Temporary Noise Barrier Strategy - Kingsgrove

Project Name: WestConnex New M5

Project number:	15.7020.2597
Document number:	M5N-CN-PLN-WSW-001
Revision date:	04/09/2018
Revision:	03

Figure 2.2 – Extract from Construction Noise and Vibration: Temporary Noise Barrier Acoustic Report (Kingsgrove Compounds) NCA19 to NCA24

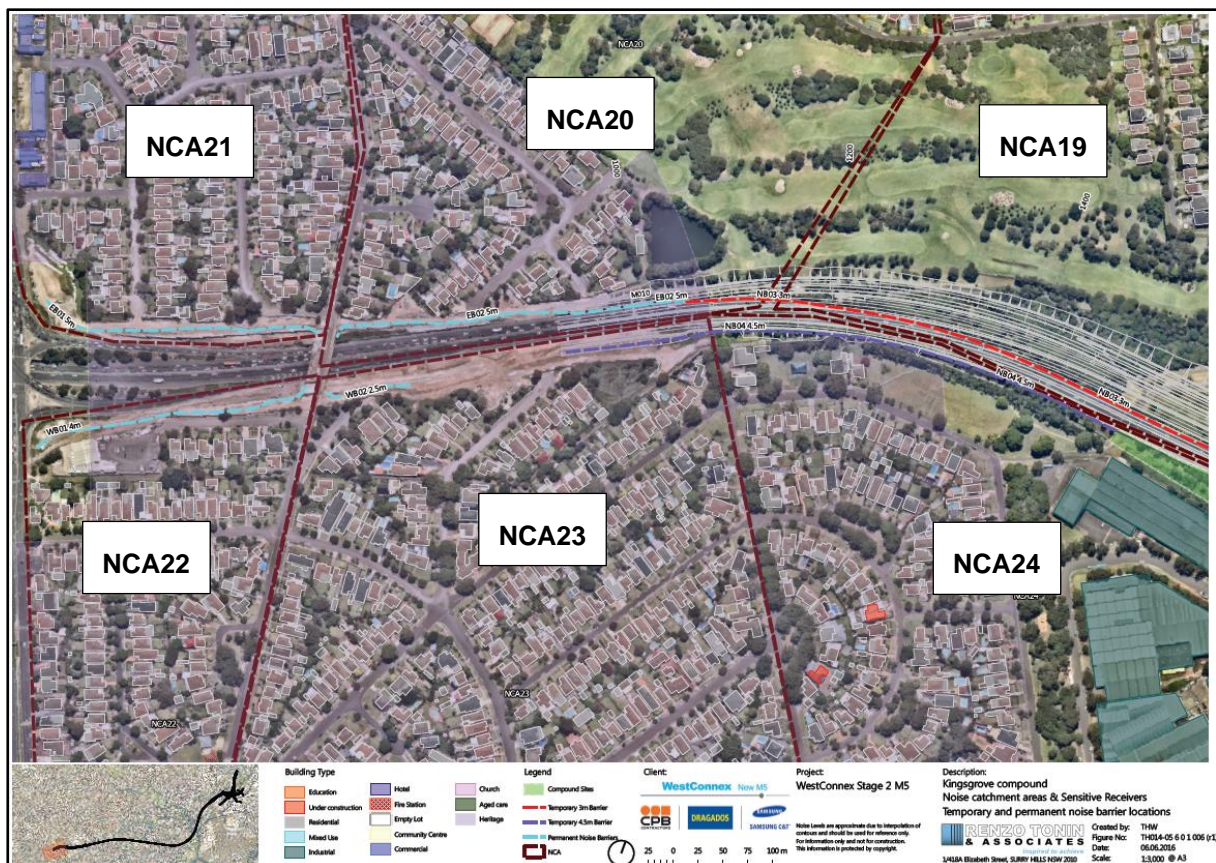
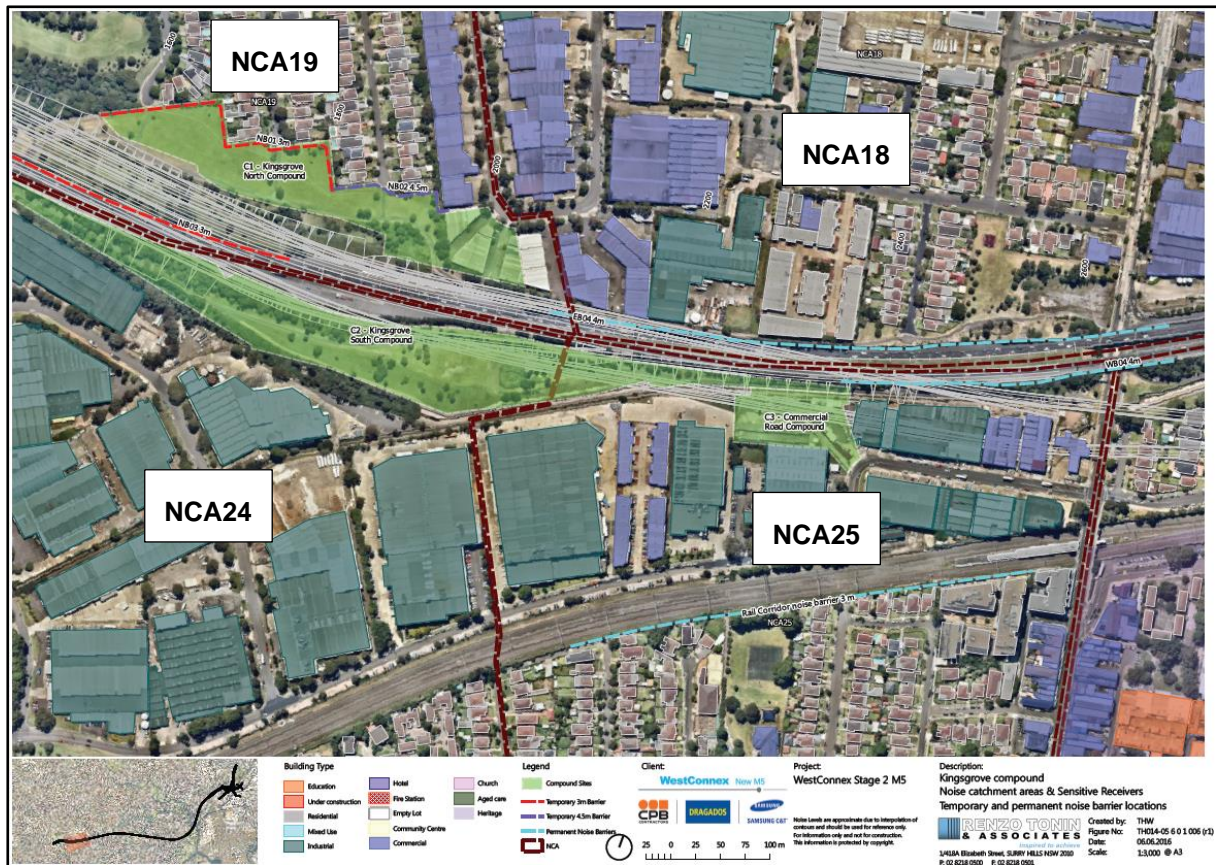
2.	The Figures from Appendix B of the Renzo Tonin report need to be included in the main body of the Strategy. Also the labels for the NCA need to be made clearer. Also some discussion on the locality of the compound noise walls, such as distance from property boundaries needs to be included in a discussion of the figures	<p>Section 2.2 – Details identified sensitive receivers and nominates NCSs in Figure 2.2 and Figure 2.3. Details regarding the location of noise barriers with reference to the nearest resident are provided in Table 2.1.</p>

Figure 3.1 – Kingsgrove North - Identified Properties Consulted – Adjacent to NB01 & NB02

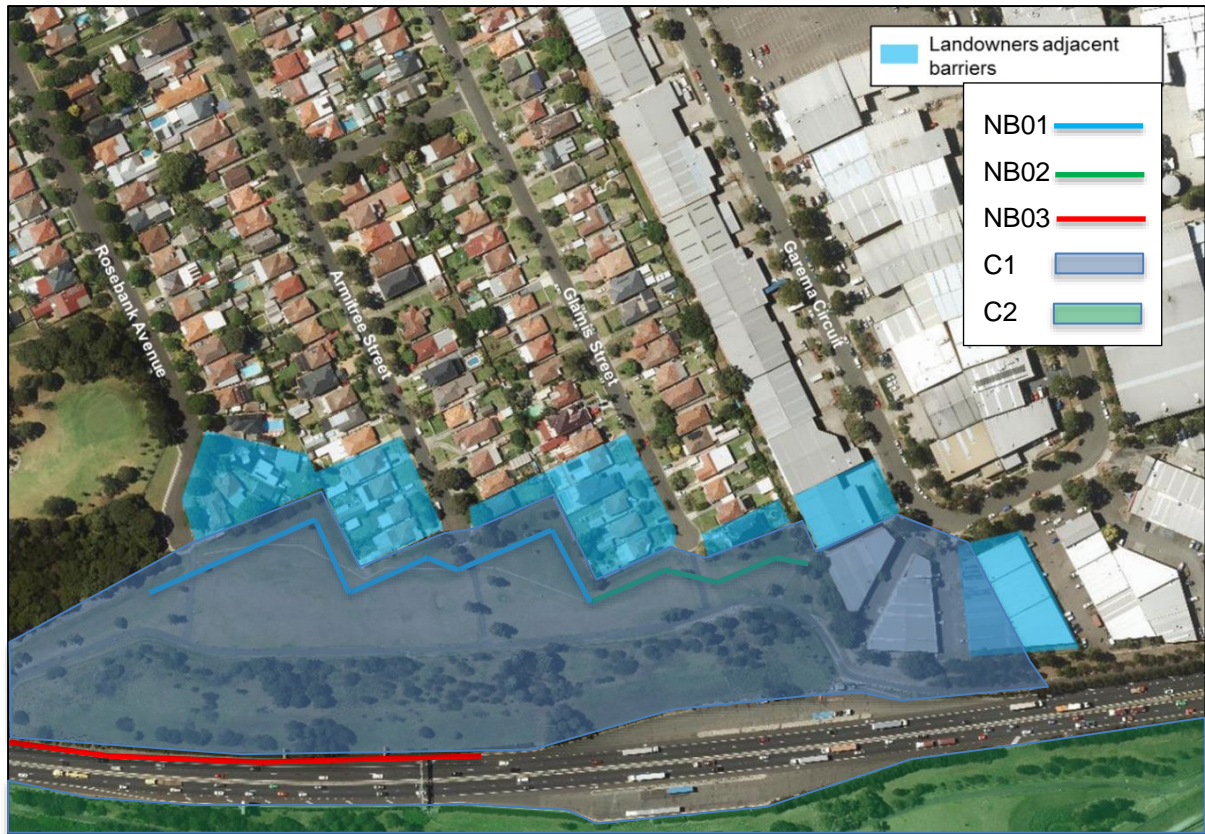
6d	Section 3.3 (last sentence) specify how many residents vs commercial properties were consulted.	Section 3.3 – This section has been amended to include a split of domestic vs commercial residents consulted
6e	Figures 3.1 and 3.2 label with compounds and show the location of barriers	Temporary noise barriers location have been added along with construction compounds.

Description:
 Kingsgrove compound
 Noise catchment areas & Sensitive Receivers
 Temporary and permanent noise barrier locations

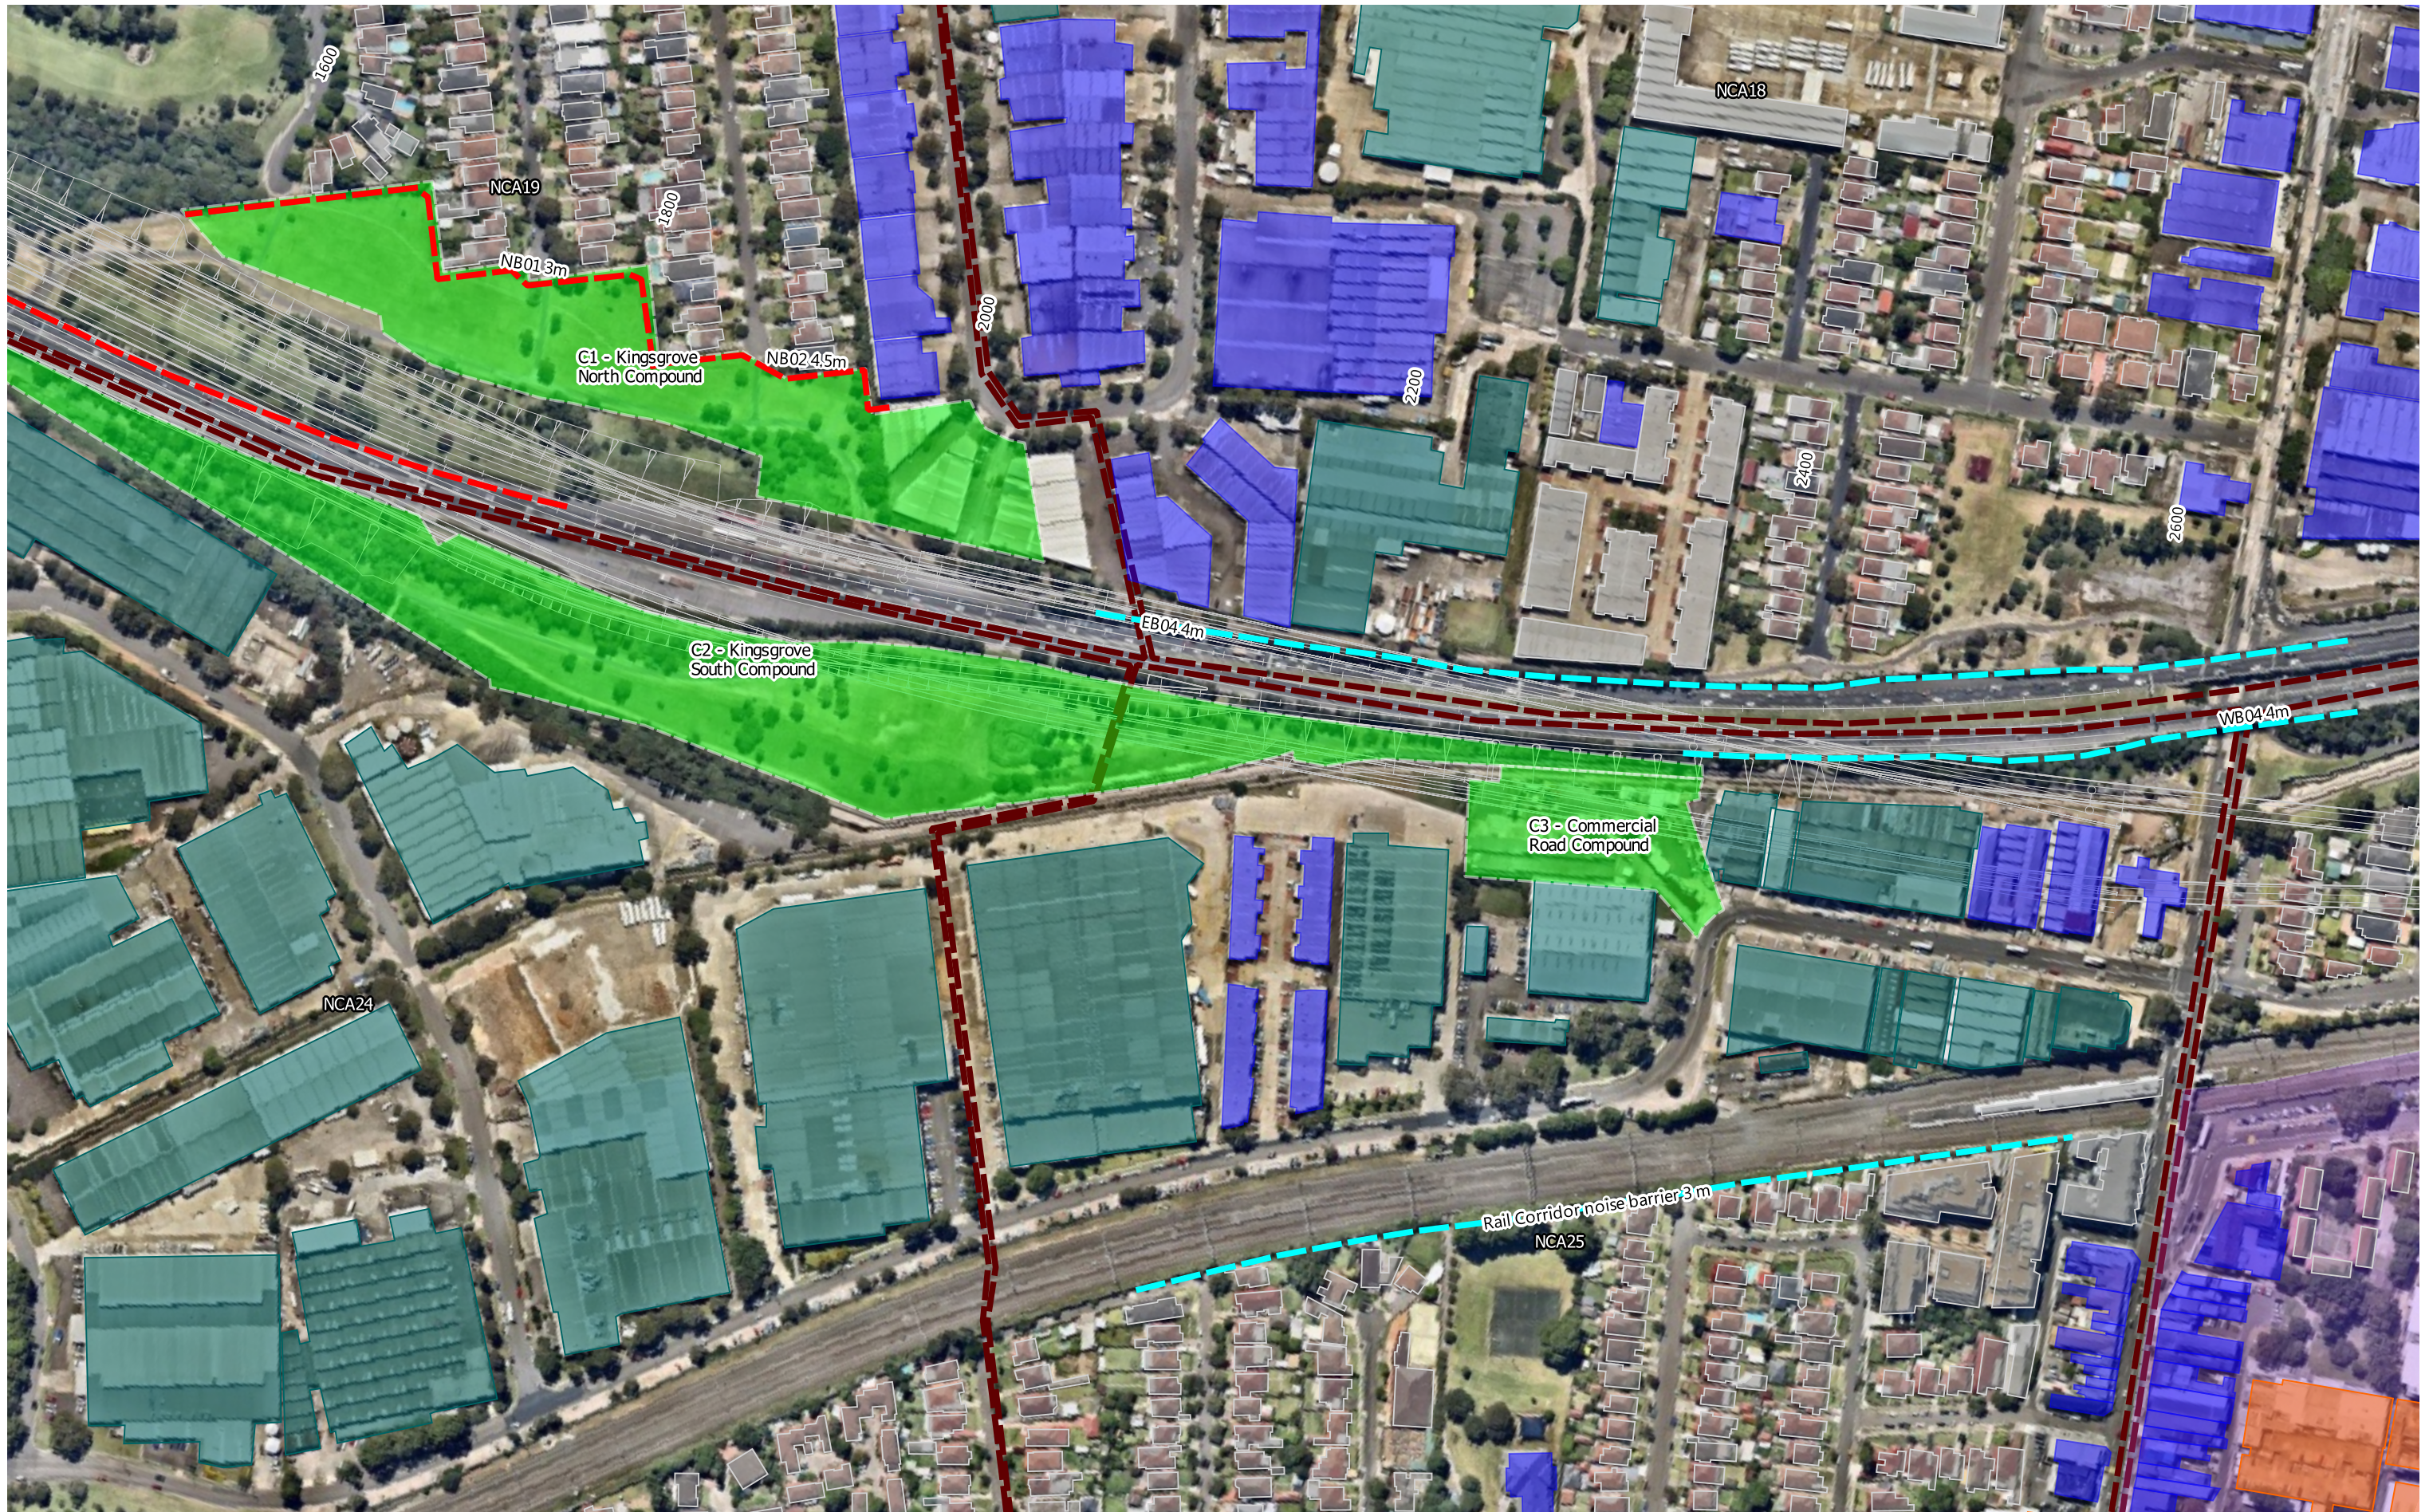
8.	Appendix A, section 2.2, page 7 – clear maps need to be included showing the NCAs and how they correspond with the noise barriers proposed in the report.	<p>Updated figures provided as below.</p> <p>Appendix A - Construction Noise and Vibration: Temporary Noise Barrier Acoustic Report (Kingsgrove Compounds)</p> <ul style="list-style-type: none"> - Appendix B – Nearest Sensitive Receivers and Noise Management Levels - Figure B.1 & B.2

9.	Appendix A – Figure B.2 is not entirely legible and does not include a legend/key.	<p>A legend is provided on updated figures as below.</p> <p>Appendix A - Construction Noise and Vibration: Temporary Noise Barrier Acoustic Report (Kingsgrove Compounds)</p> <ul style="list-style-type: none"> - Appendix B – Nearest Sensitive Receivers and Noise Management Levels - Figure B.1 & B.2
